AGENDA
CHASKA CITY COUNCIL
CHASKA CITY HALL - COUNCIL CHAMBERS & ZOOM
Monday, May 19, 2025
7:00 PM

Subject: EDCO – Creek Road – Preliminary Site & Building Plan, Preliminary Plat & Rezoning

Synopsis: The applicant is requesting a Preliminary Site & Building Plan, Preliminary Plat and Rezoning approval for a two-story office/manufacturing/warehouse building totaling approximately 235,000 square feet

Figure 6: Exhibit showing conceptual access to 2.8-acre Haasken property

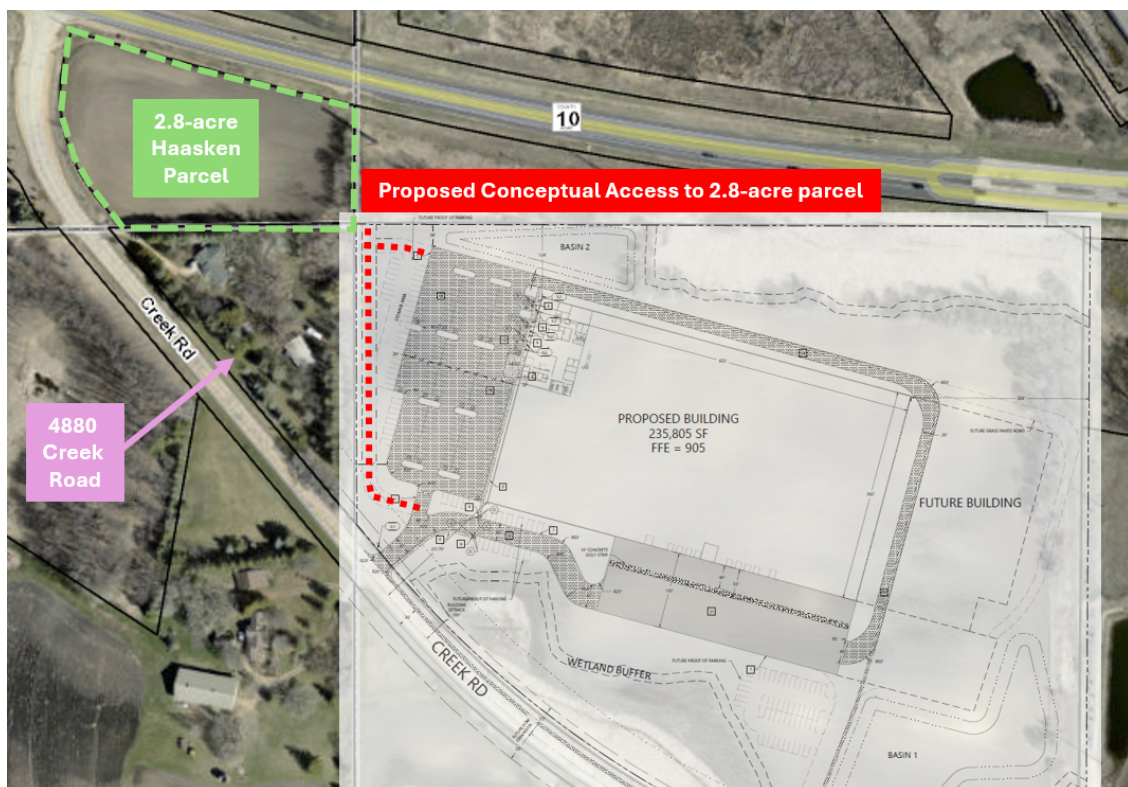
The proposed EDCO site is currently owned by the Haasken family. The Haasken family also owns a 2.8 acre property that touches the northwest corner of the property (see Figure 6 below). Being that this 2.8 acre property is located on a corner of a major county highway, there is a question on how access spacing will be achieved off of Creek Road. EDCO is planning to purchase this 2.8 acre property so that access to the 2.8-acre property from their site can be better understood and controlled. EDCO does not have any intentions to develop on the 2.8-acre property currently. The exhibit below shows a conceptual layout for how the 28-acre parcel can provide future access to the 2.8-acre property. Unfortunately, the properties do not directly abut so access cannot be achieved without participation from the neighboring property at 4880 Creek Road. The applicant will have to show in their final submittal how a conceptual access can be achieved to the 2.8-acre parcel through EDCO's site and 4880 Creek Road should both 4880 Creek Road and the 2.8-acre property be developed.

WHEREAS, the applicant will have to show in their final submittal how a conceptual access can be achieved to the 2.8-acre parcel through EDCO's site and 4880 Creek Road should both 4880 Creek Road and the 2.8-acre property be developed and contemplate an alternative access through EDCO's site; and

Figure 7: Access Alignments

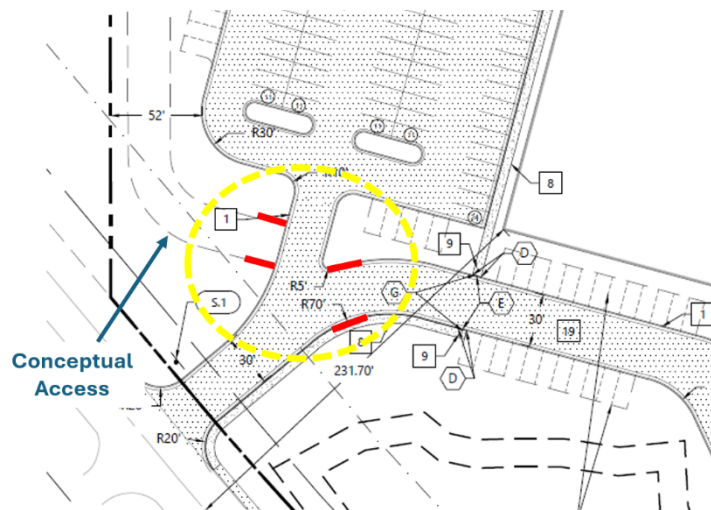
As discussed above under Layout, the applicant will have to show in their final submittal how a conceptual access can be achieved through EDCO's site and 4880 Creek Road should 4880 and the 2.8-acre property be developed. Currently the site plan is showing a conceptual access on the west side of the site. The access is located at an intersection, which does not show alignment with the truck access (see figure 7 below). The applicant will have to further evaluate this alignment in their final submittal.

Figure 8: Proposed Landscape Plan and Screening Opportunities

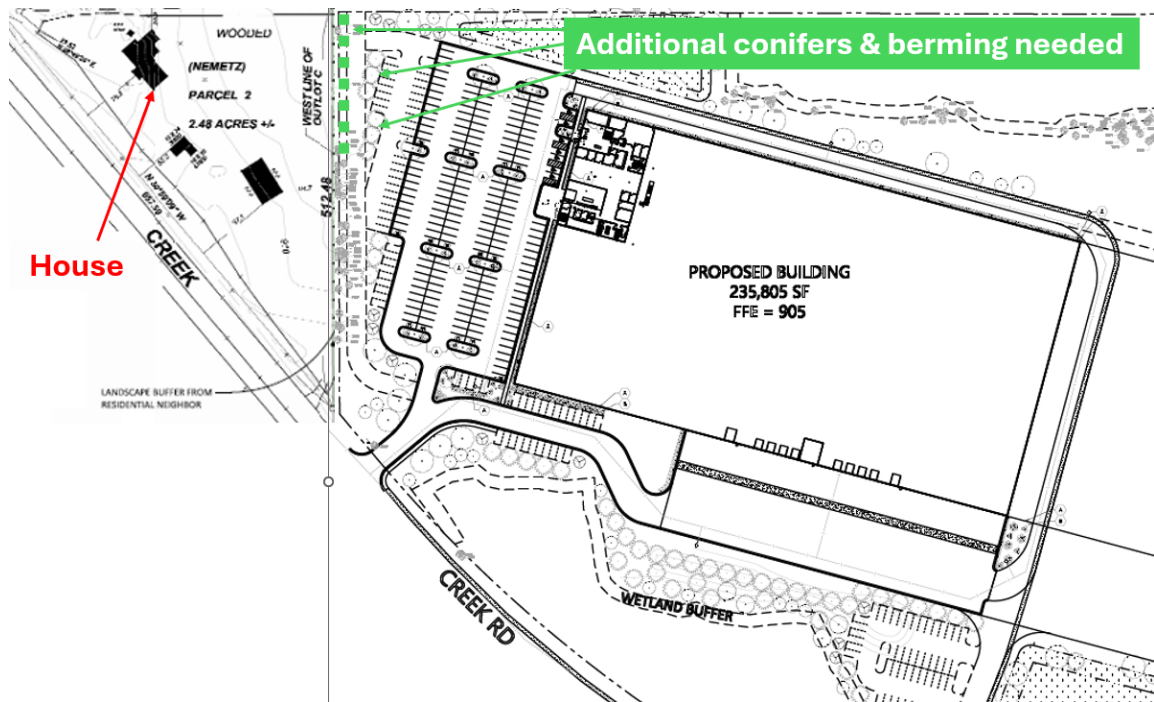
Based on the table above the applicant is insufficient in all landscaping categories required for the site. The applicant will have to show in their final submittal how they meet the landscape ordinance (Section 15.28.070) for all categories.

In addition, screening will be important for this site along sides that abut major vehicular thoroughfares and residential uses. The west neighbor is a residential use so it will be important that the west edge and parking lot of the site is properly screened via landscaping and berming. A healthy layer of mature trees straddle the lower, western property line which provide an existing screening effort. Additionally, the proposed grading plan shows the inclusion of an approximately 4-foot berm along the west side of the parking lot. The berm starts to taper down in height as it approaches north. The landscaping plan also shows a single layer of coniferous plantings on the west side (see figure 8). In sum, the northwest corner could use additional plantings and berming as it is within the direct line of sight of the adjacent home. Staff would advise the applicant to further evaluate the inclusion of a taller berm and additional layer of conifers in this area.

- ii. Additional plantings on the northwest edge of the site to help screen the parking lot from adjacent residential

Figure 9: Proposed Landscape Plan and Berming Opportunities

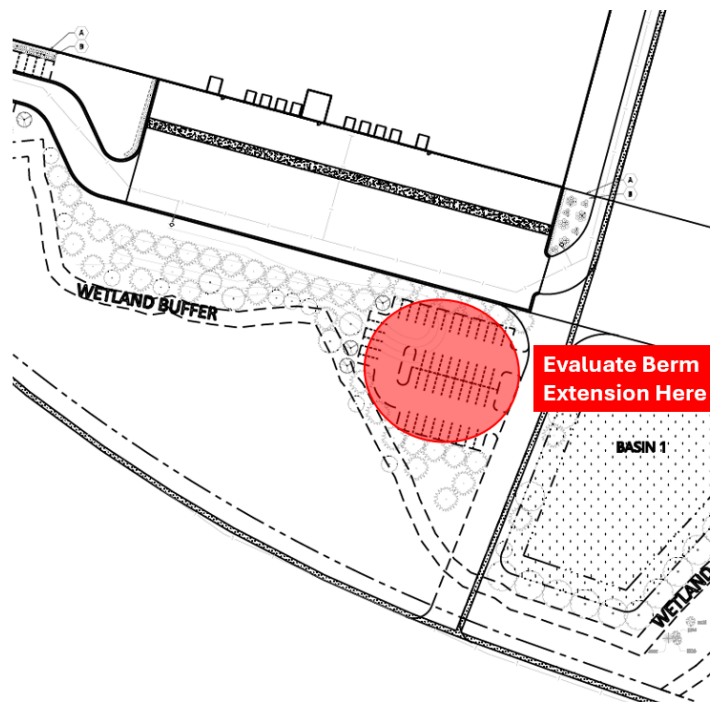
The loading dock area is also an area that needs to be screened from Creek Road and neighboring residents. The grading plan shows the inclusion of an approximate 6-8 foot berm along the south side of the loading dock area with a multi-layer of plantings. Staff would advise the applicant to further evaluate extension of the berm east towards the proposed secondary truck access as a part of their final plan.

- c. Grading plans, including extension of the screening berms on the west and south sides of the site as directed in the staff report;
 - d. Stormwater plan; and
